Product Change Notification / RMES-22JKYM836

CCB 4270 Final Notice: Qualification of GTK as a new assembly site for selected Atmel products available in 28L SOIC (.300in) package.

PCN#: RMES-22JKYM836

Tube Drawing

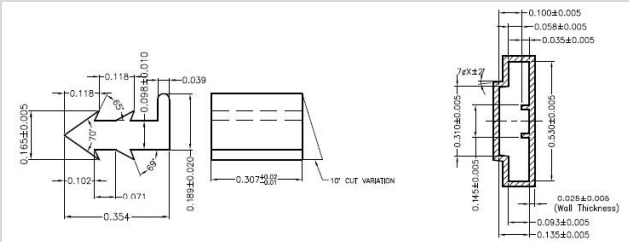
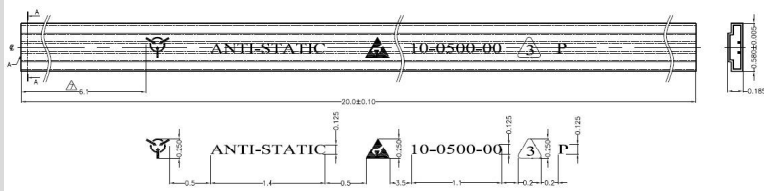
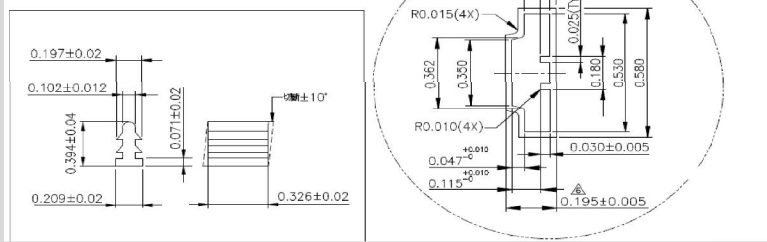
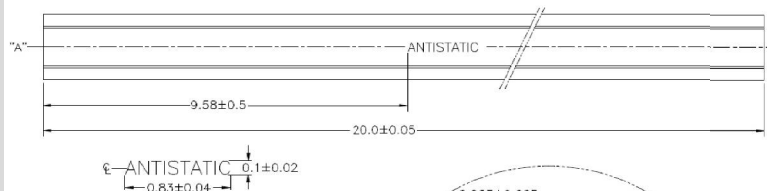
Packing Information (Tube Comparison)

Package	Lead Count	Body Size	Units/Tube	Length (inch)	End Plugs	Package	Lead Count	Body Size	Units/Tube	Length (inch)	End Plugs
SOIC	28	300 mils	27	20+/-0.10	Black/Black	SOIC	28	300 mils	27	20 +/- 0.05	Blue/White
